HISTORIC AND DESIGN REVIEW COMMISSION

Agenda Item No: 21

HDRC CASE NO: 2015-311
ADDRESS: 214 W LULLWOOD AVE
LEGAL DESCRIPTION: NCB 6533 BLK 13 LOT 29, AND 30
ZONING: R5 H
CITY COUNCIL DIST.: 1
DISTRICT: Monte Vista Historic District
APPLICANT: Adan Ochoa
OWNER: Michelle Nievaard
TYPE OF WORK: Amendment to New Construction of a Garage
REQUEST:

The applicant is requesting to amend a previously approved Certificate of Appropriateness at 214 W. Lullwood Ave. The requested design amendments include:

OVERALL FLOOR PLAN

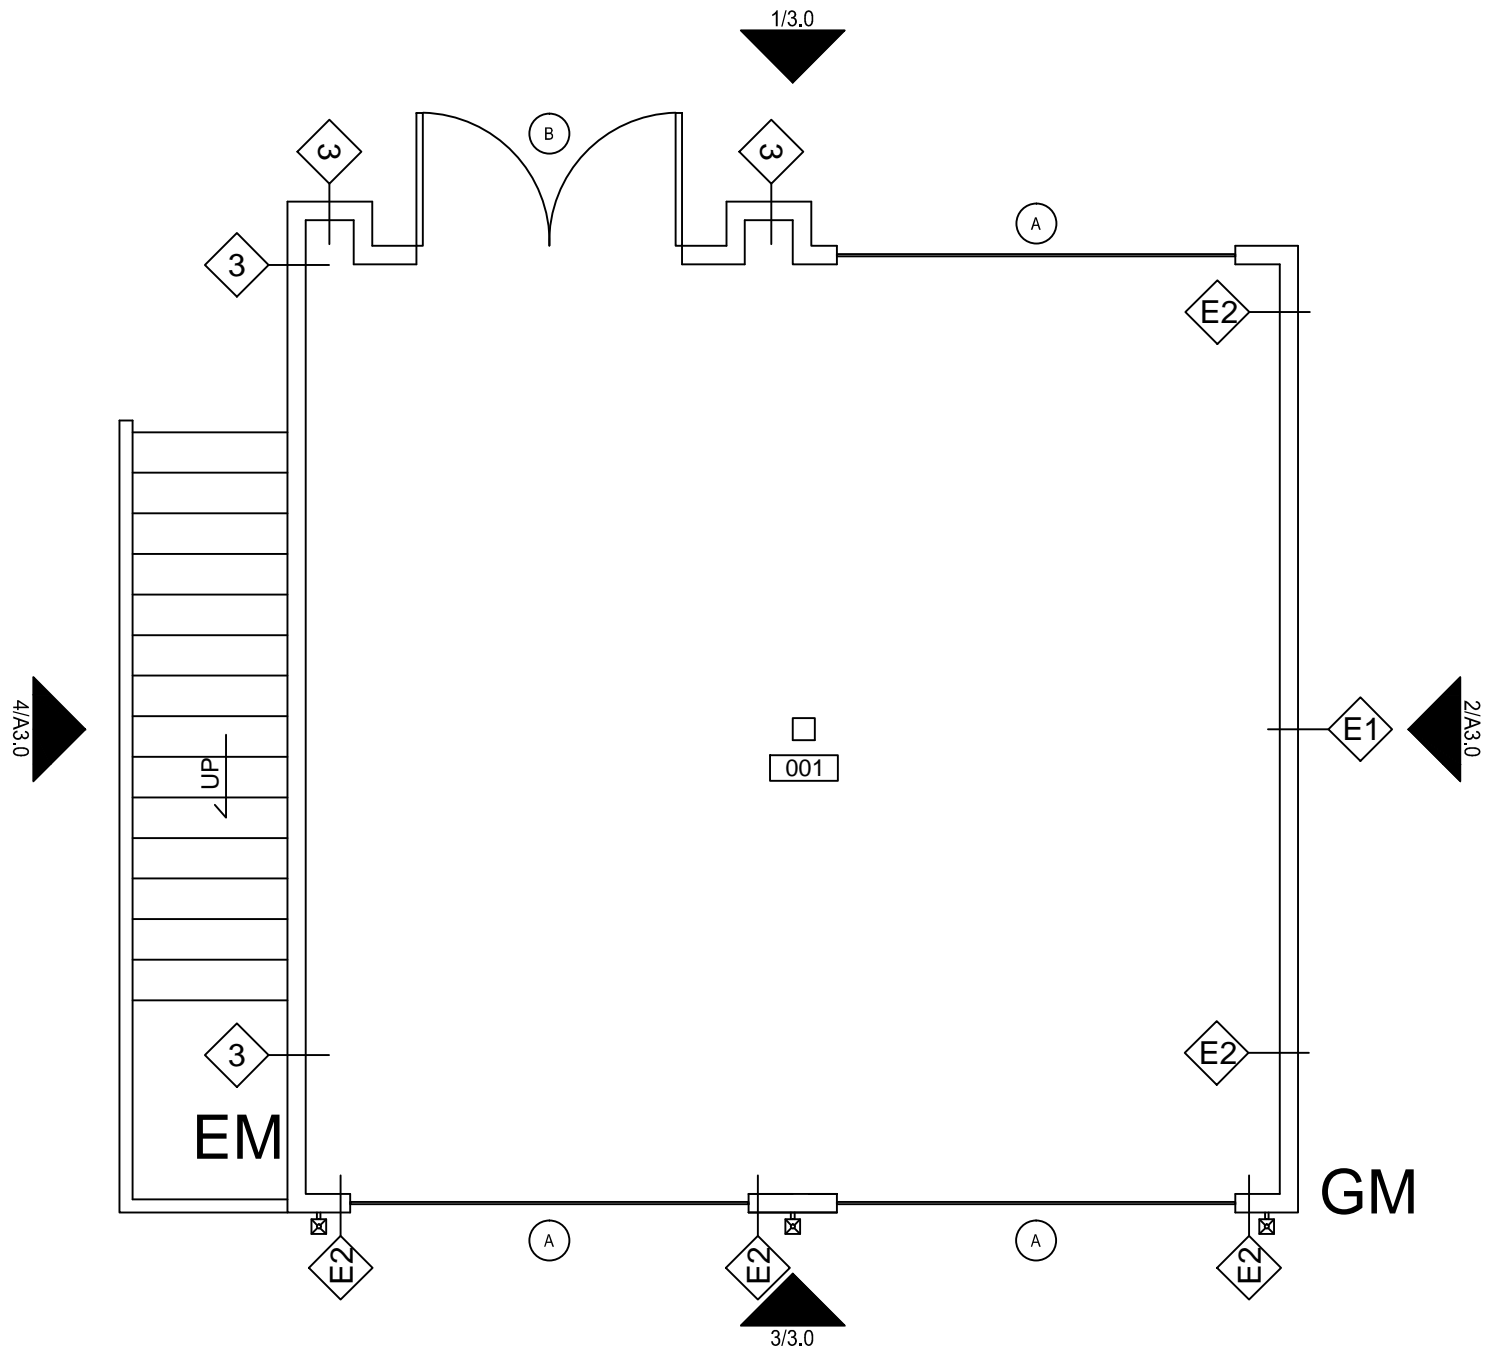
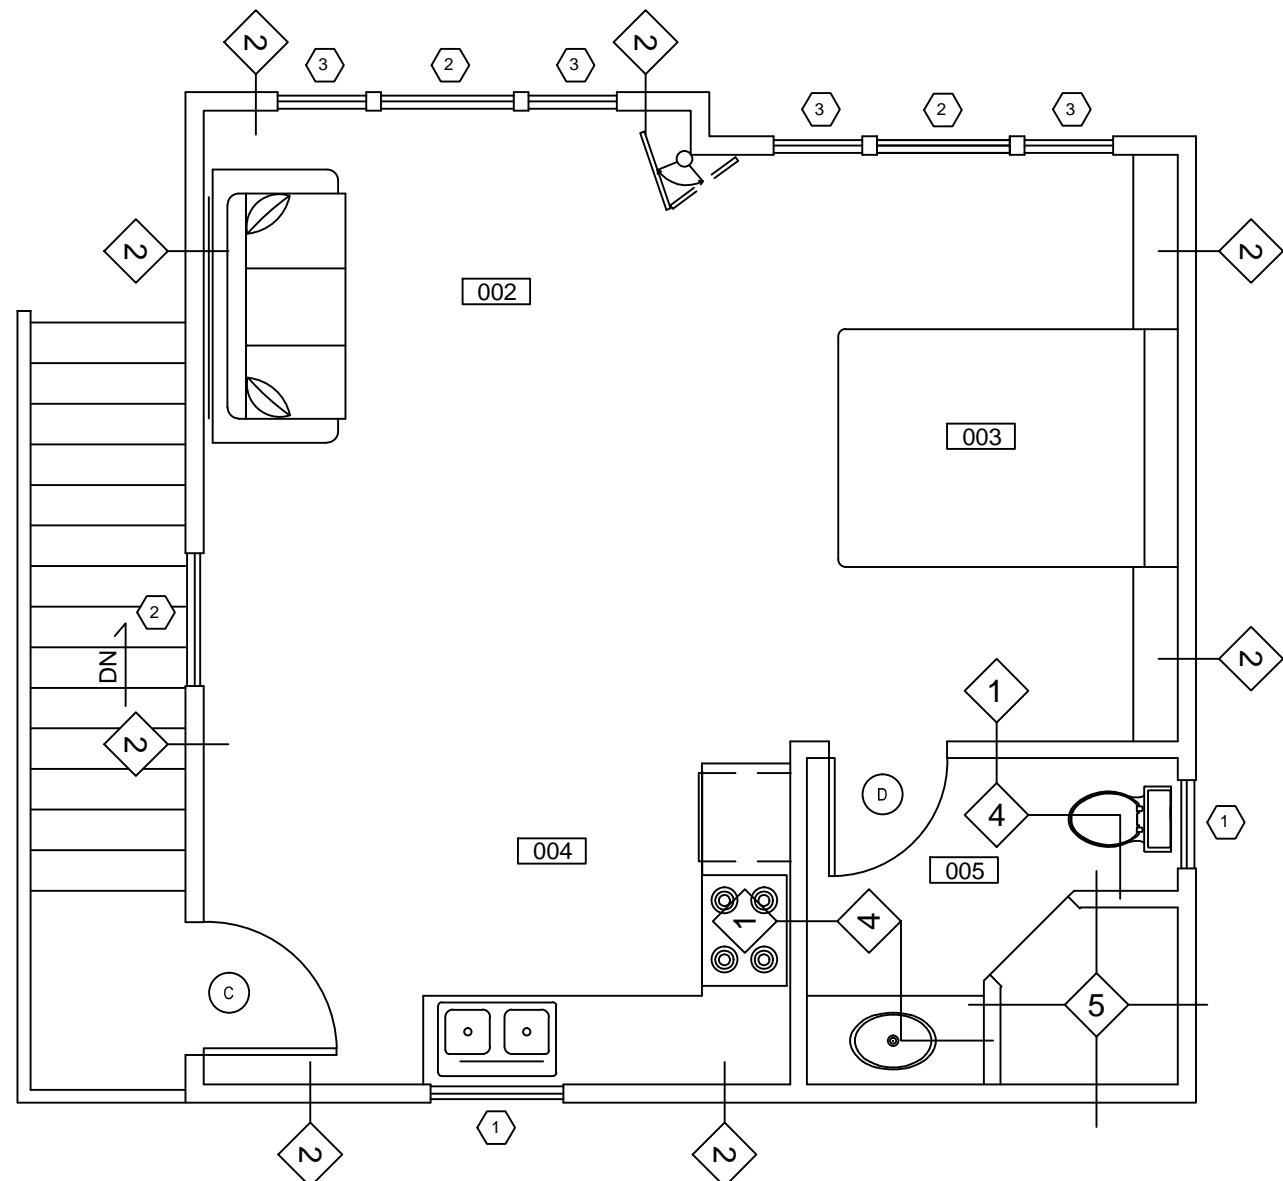
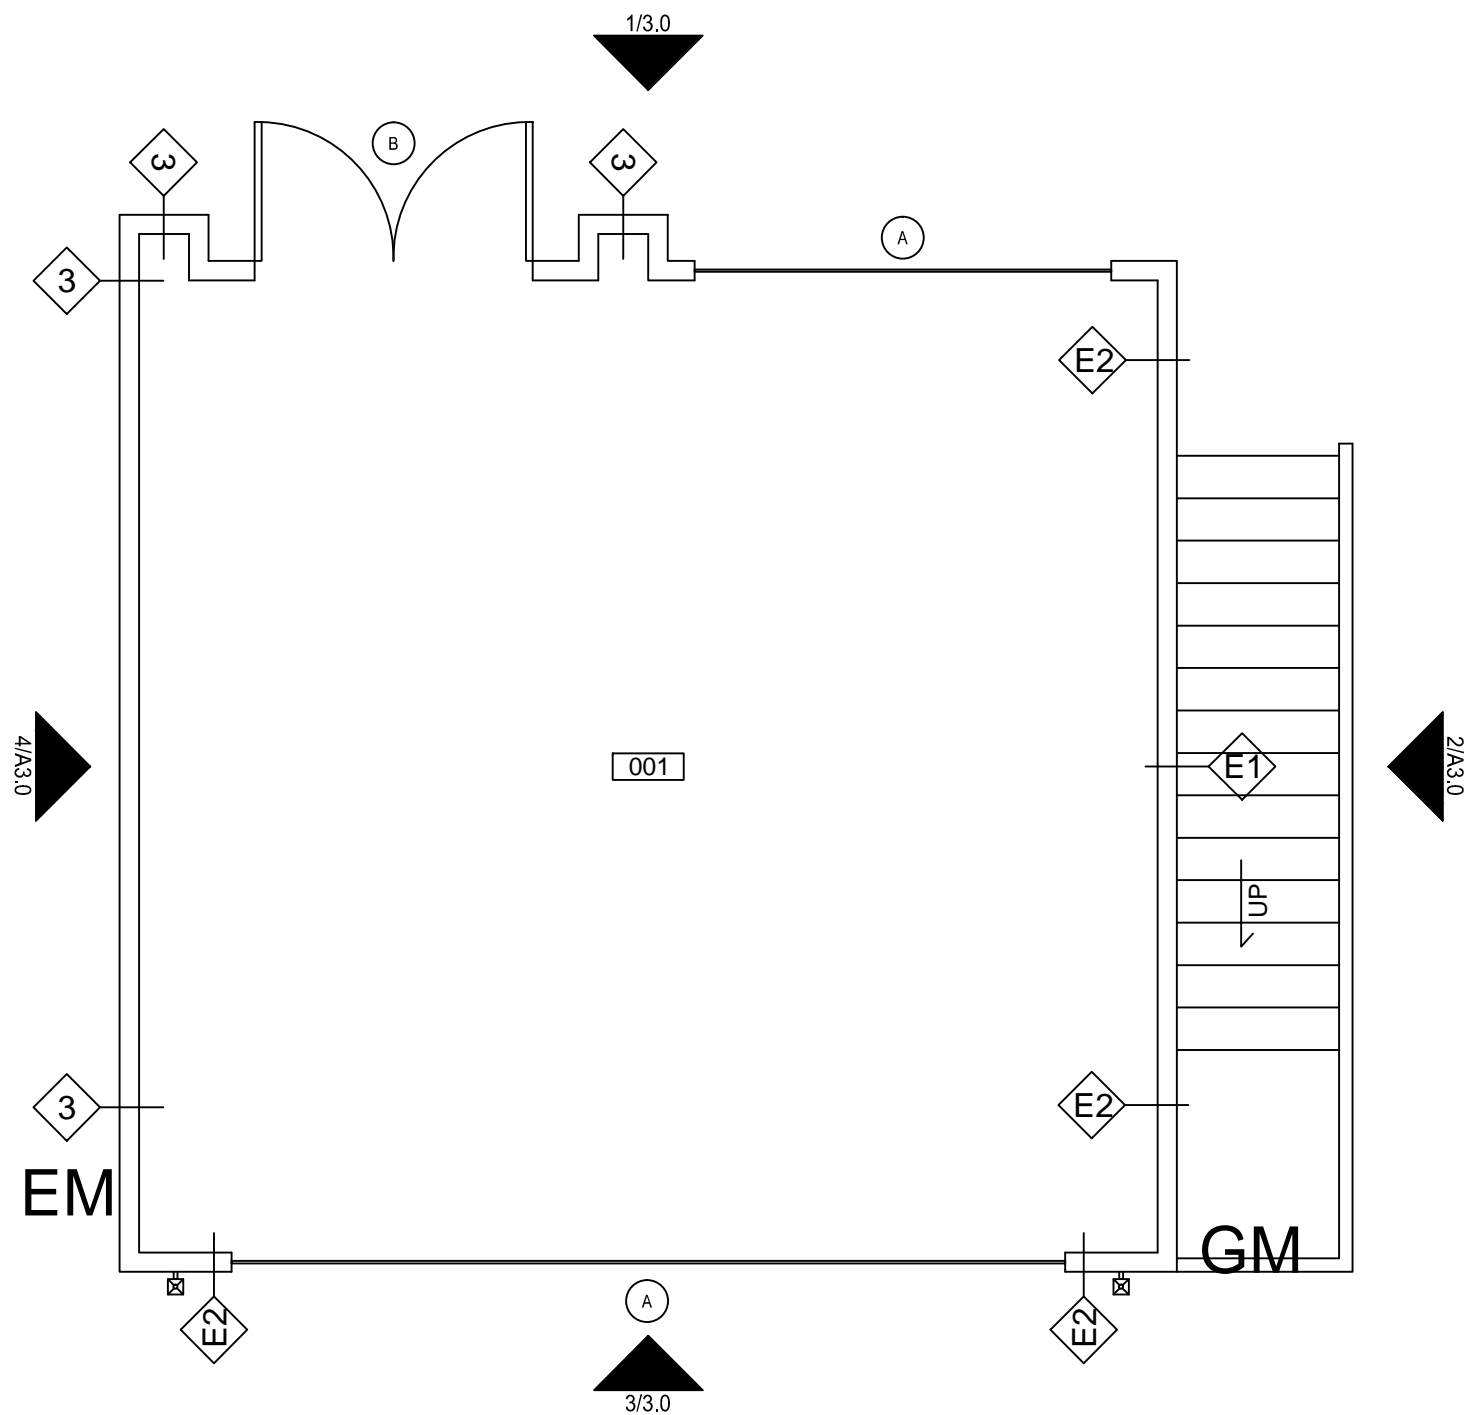
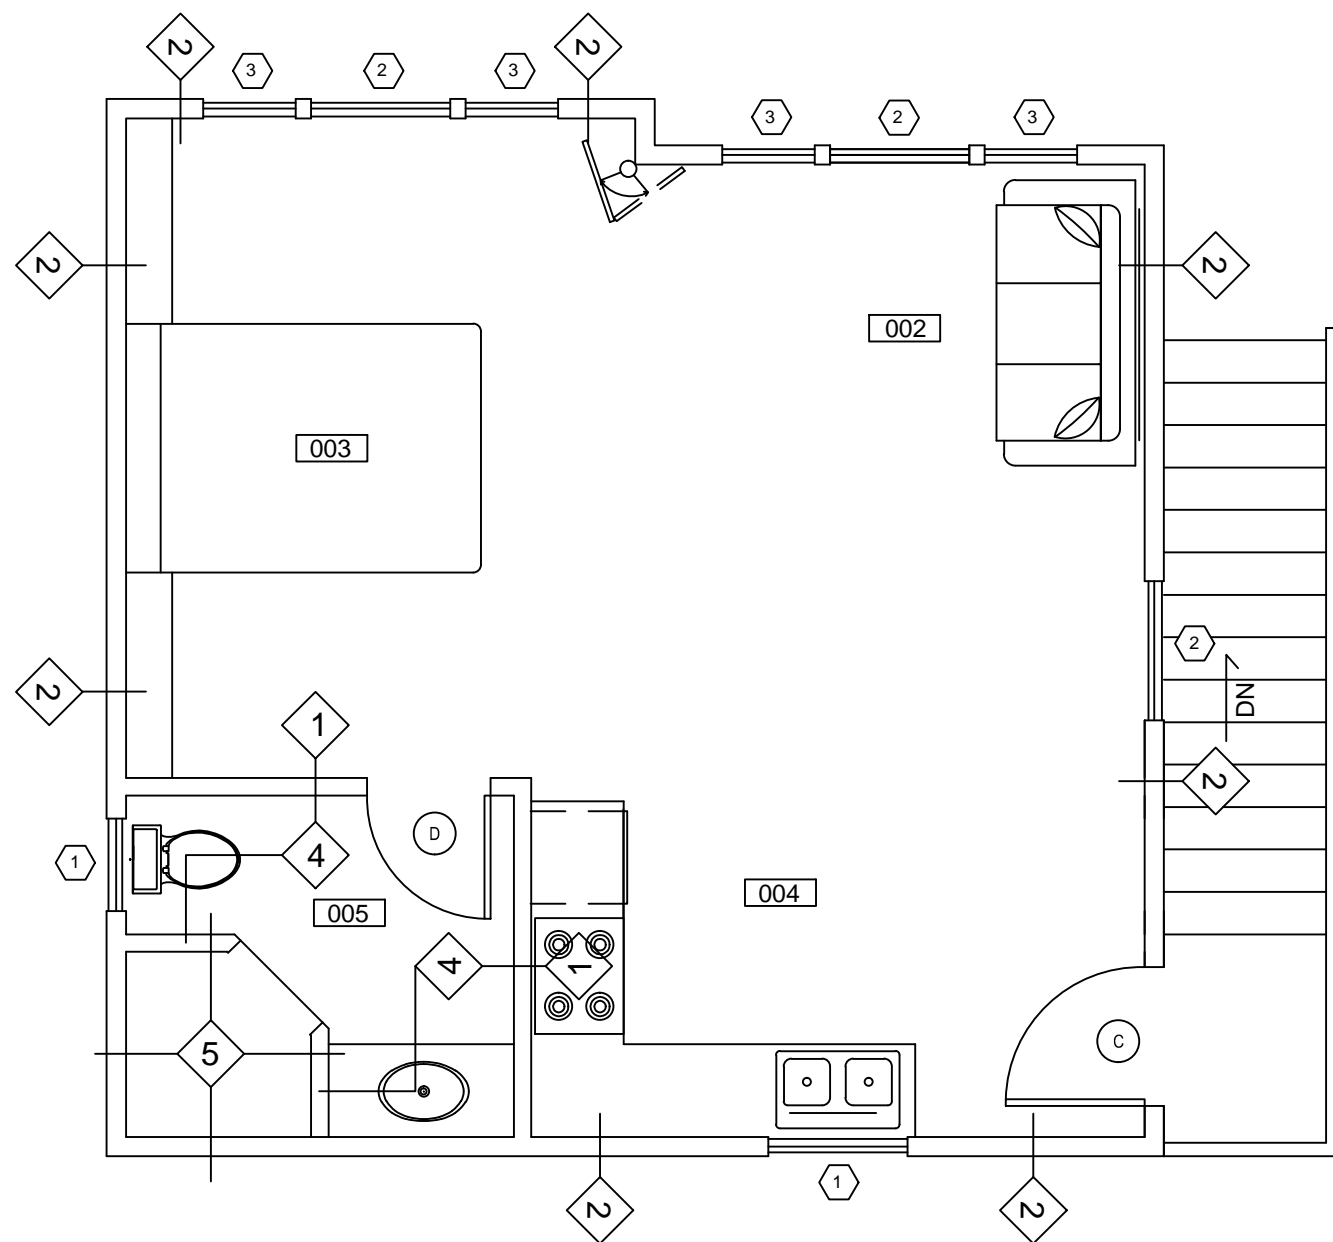
1. Moving the stairs from the west side of the structure to the east side.
2. Construct one garage opening (as opposed to two) along the alley.

Staff recommends approval of item 1 based on finding b. Staff does not recommend approval of item 2 based on finding c.
